SUBJECT: Response to Site Investigation Work Plan, Interim Site Investigation Report, Conceptual Site Model and Aerial Deposition Evaluation Report
JCI/Tyco Stanton (PFAS), 1 Stanton Street, Marinette, WI
BRRTS #02-38-581955

Response to Site Investigation Work Plan Interim Site Investigation Report,
 Conceptual Site Model and Aerial Deposition Evaluation Report
 BRRTS #02-38-581955

FIGURE 1-4
 Conceptual Site Model Post-barrier Wall
 Tyco Fire Products LP
 Marinette, Wisconsin

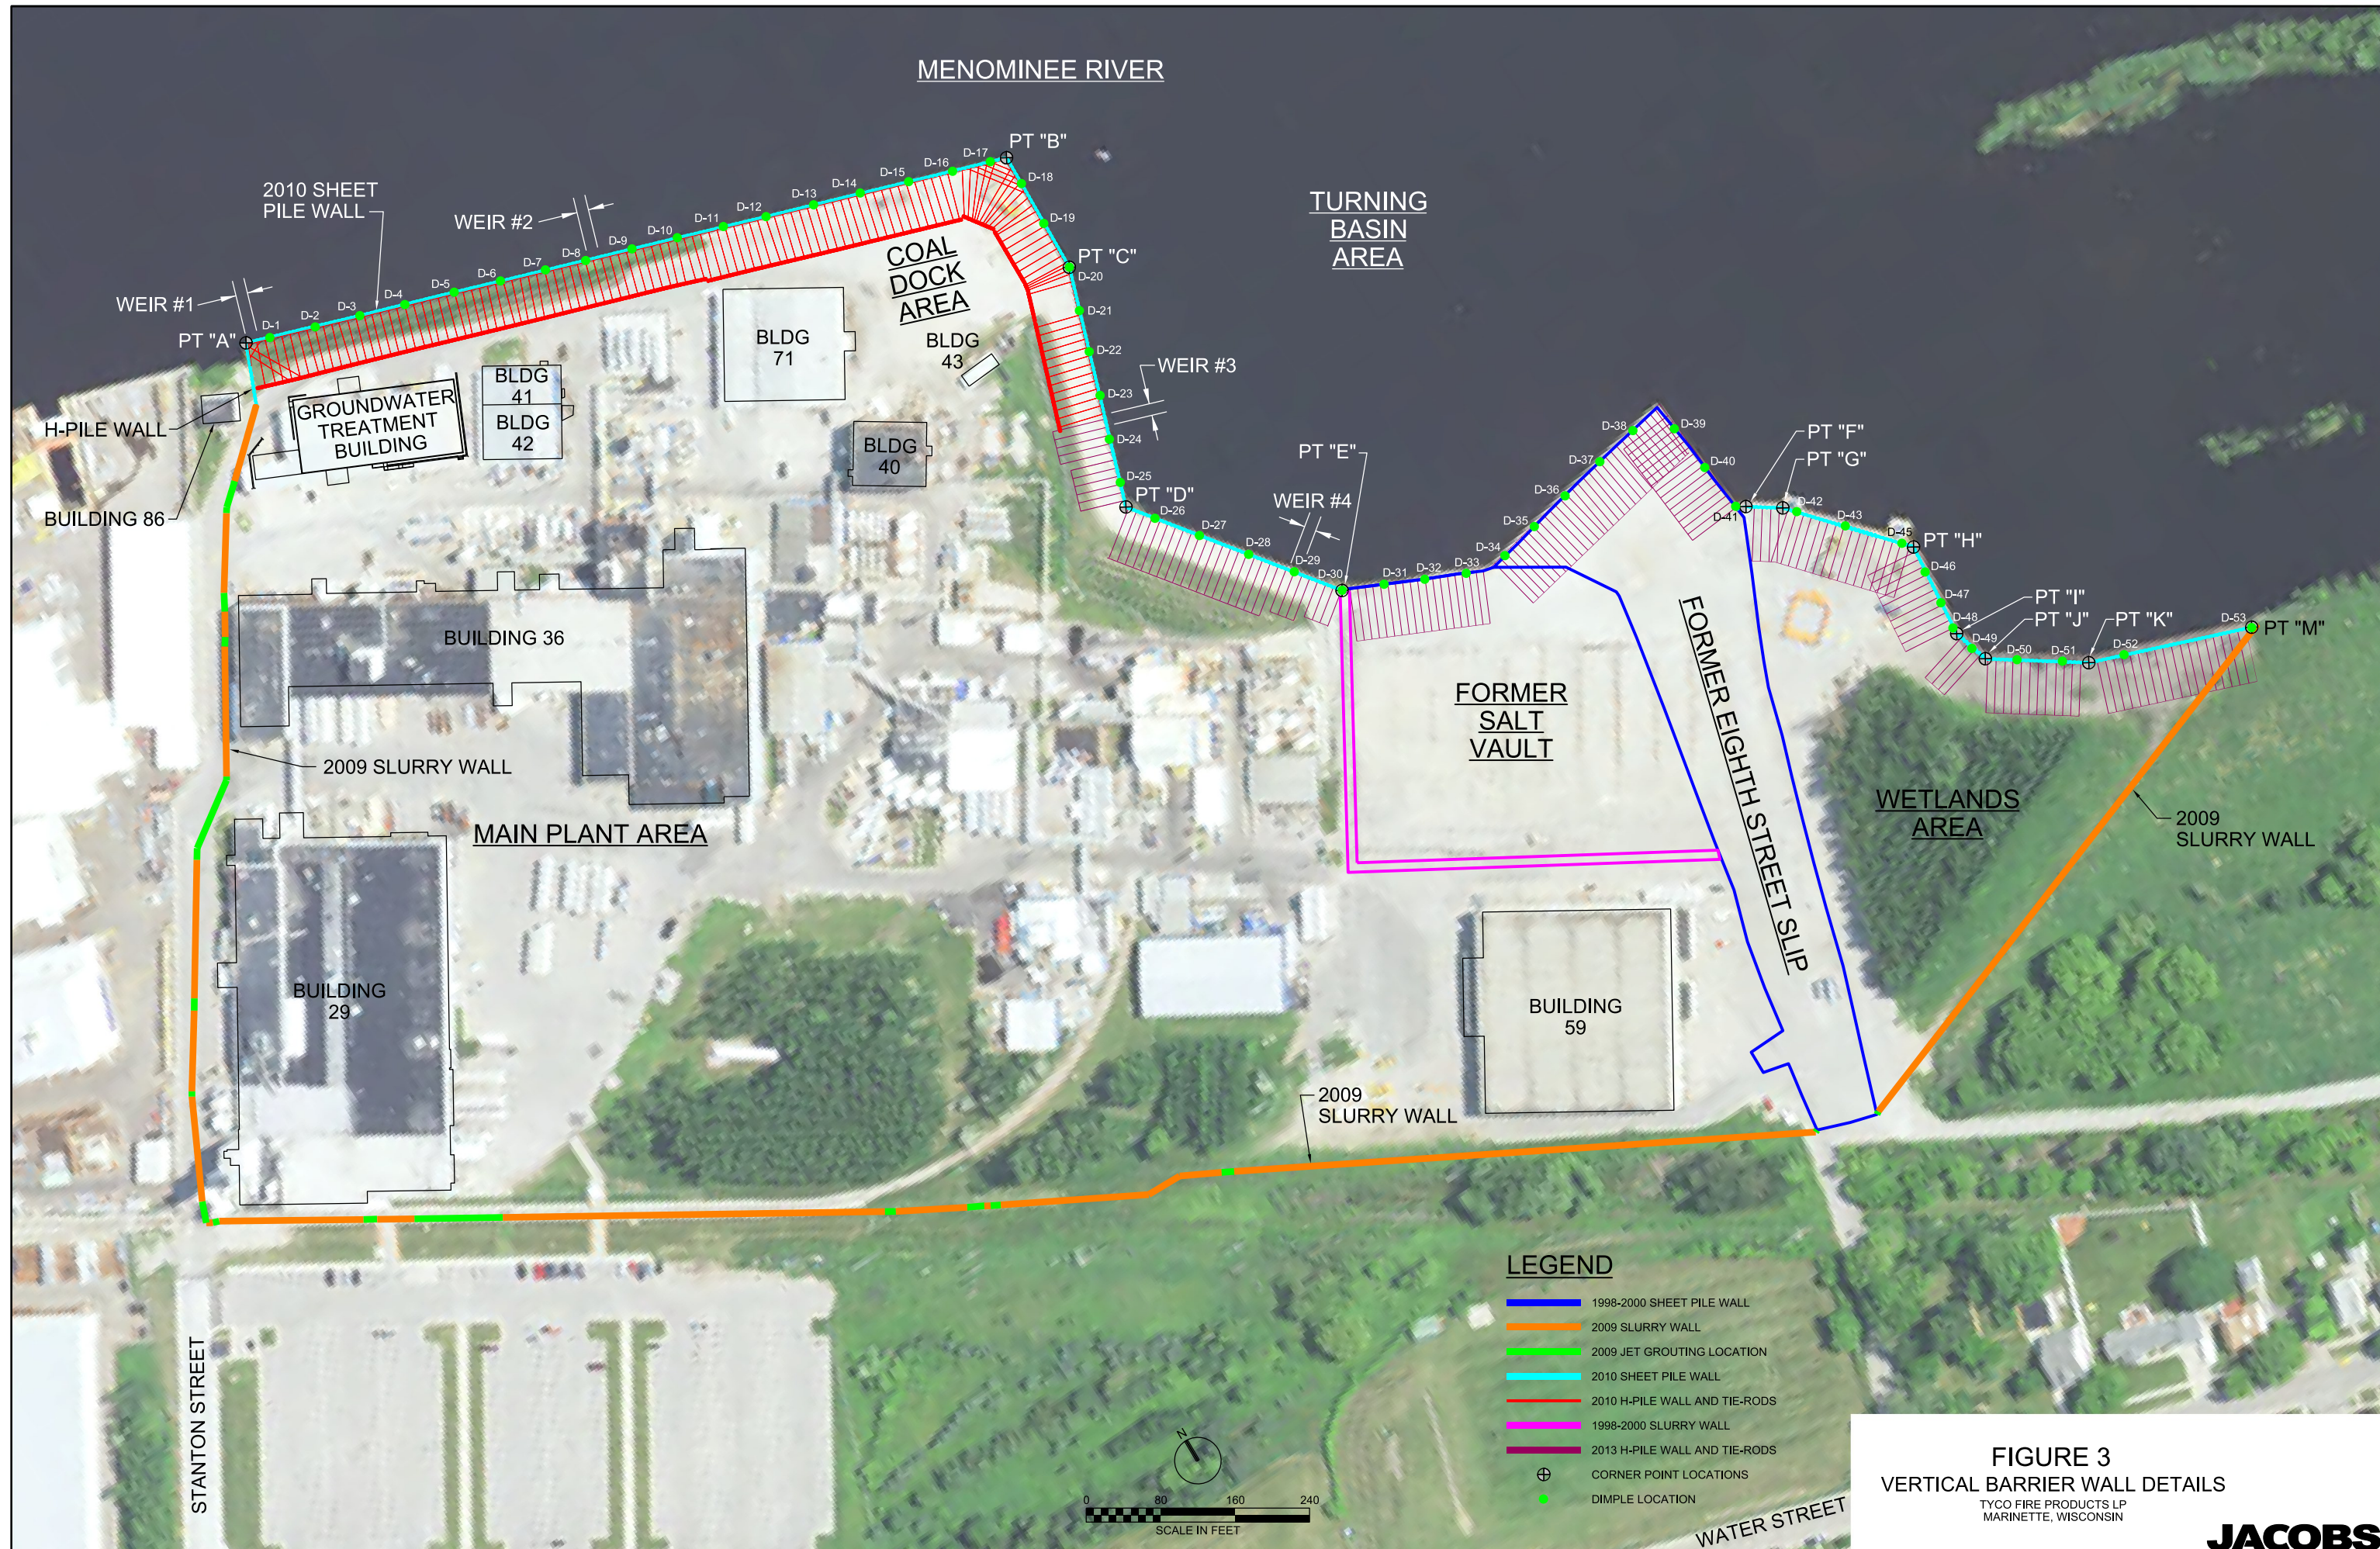
The 66-acre property was investigated and underwent RCRA corrective action measures for the arsenic contamination under BRRTS case #02-38-000011 ("Arsenic RCRA Site"). The conceptual layout and overviews based on the prior investigation and corrective actions are shown on CH2MHill's Figure 1-4 and Jacobs' Figure 3 in **Attachment A**.

- Groundwater in the unconsolidated zone on the property is contained, to the extent possible, within a barrier wall that was installed around the perimeter of the property by 2010. The barrier wall is keyed into the low-permeability glacial till and includes a slurry wall along the upland perimeter and a sheet pile wall along the Menominee River (see CH2MHill's Figure 1-4 and Jacobs' Figure 3 in **Attachment A**).

FIGURE 3
VERTICAL BARRIER WALL DETAILS
 TYCO FIRE PRODUCTS LP
 MARINETTE, WISCONSIN

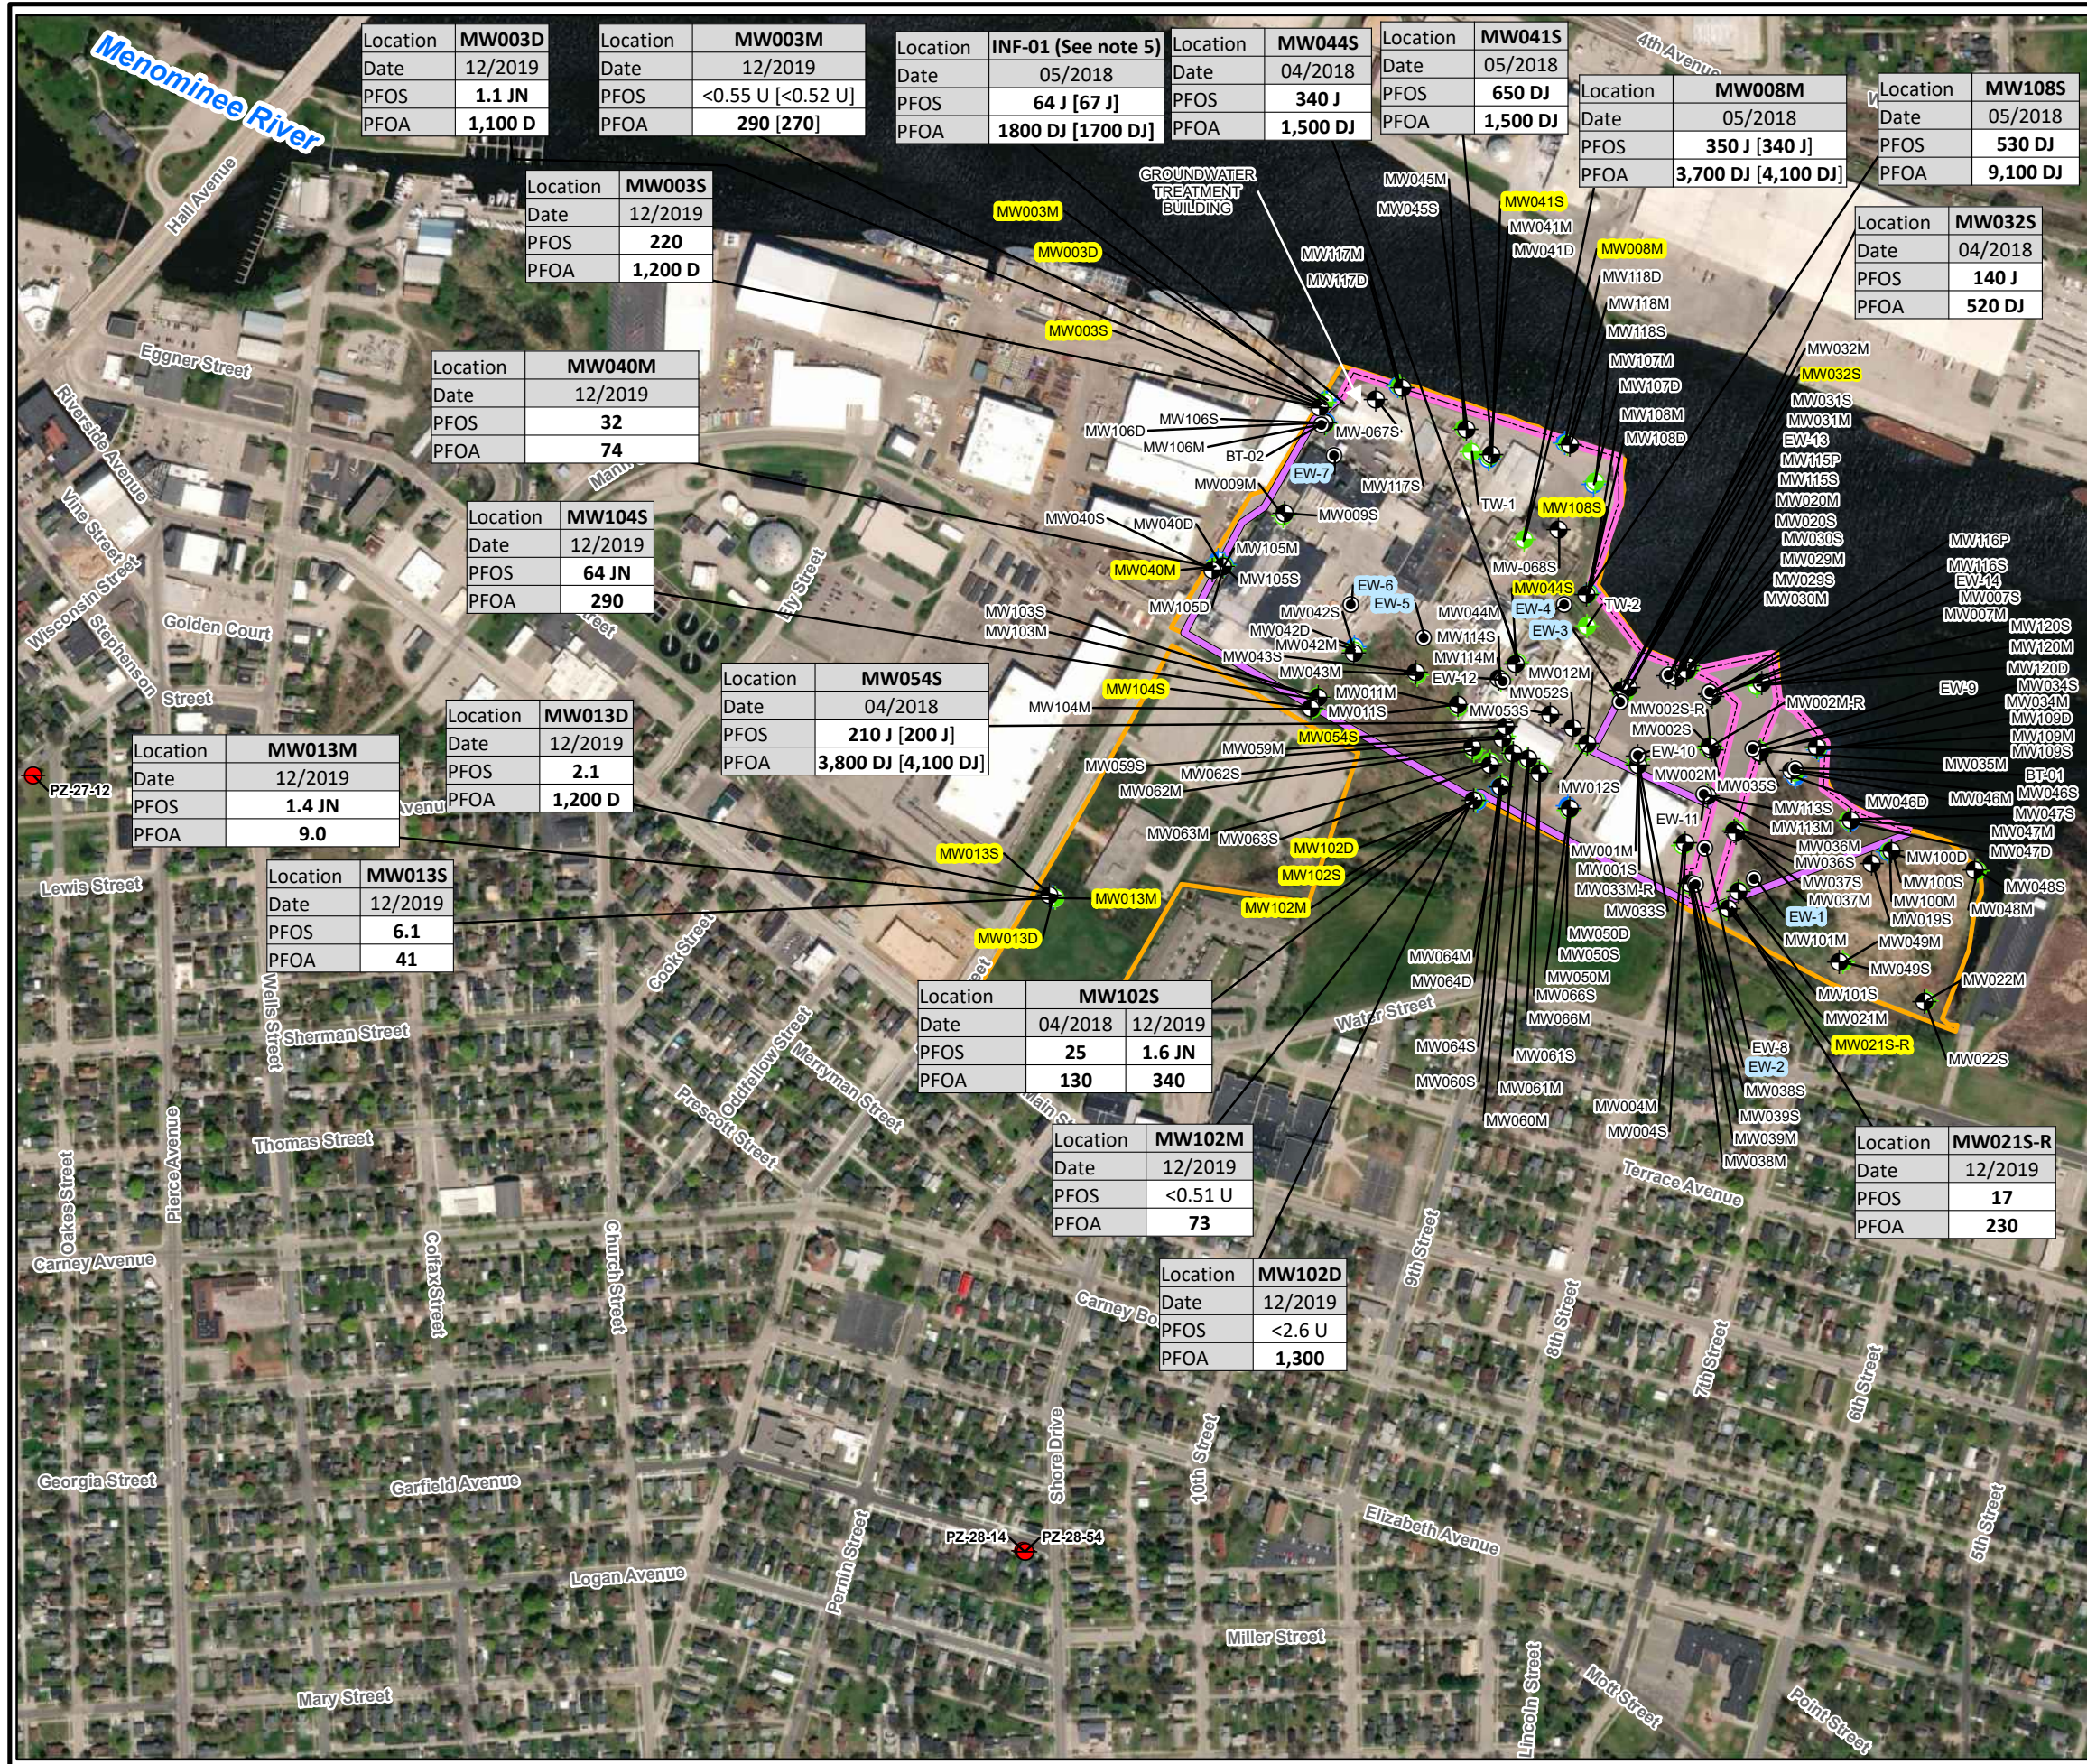
Data Gap #5a: Evaluation on the effect flooding and varying water levels in the Menominee River have on PFAS concentrations measured in groundwater at the Site and potential PFAS migration from the Site in discharge to Menominee River over the barrier wall, through weirs and/or other outlets. (Location of weirs are shown on Jacob's Figure 3 in **Attachment A**.)
